SUBJECT: Operational Report - Lessons Learned, Headquarters, 84th Engineer Battalion, for Period Ending 30 April 1970

SUBJECT: Operational Report - Lessons Learned, 84th Engineer
Battalion (Construction), for the period ending 30 April 1970
RCS CSFOR-65 (R2)

EGC-OP (30 April 1970) 1st Ind
SUBJECT: Operational Report - Lessons Learned, 84th Engineer Battalion
(Const), Period Ending 30 April 1970.

CAUSEWAY
BONG SON BRIDGE

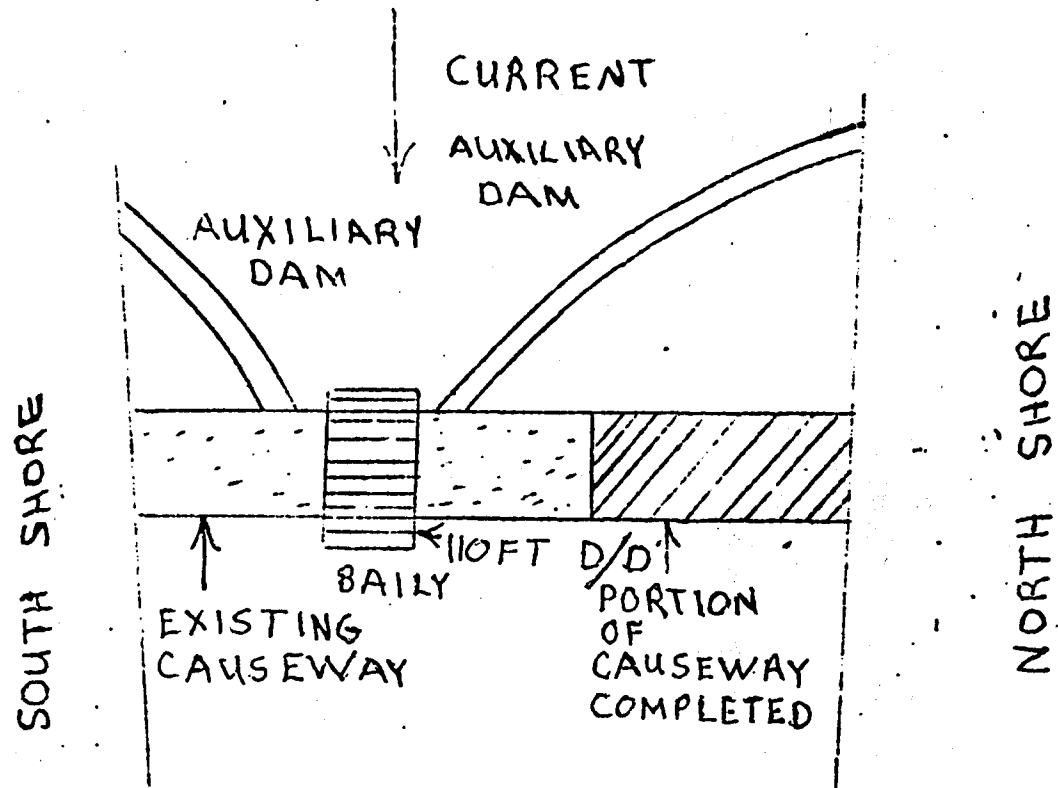
b. Reference: Para 2(b)10. Causeway. A simpler method would be to add blast rock as a rip-rap at ends of the causeway adjacent to stream.
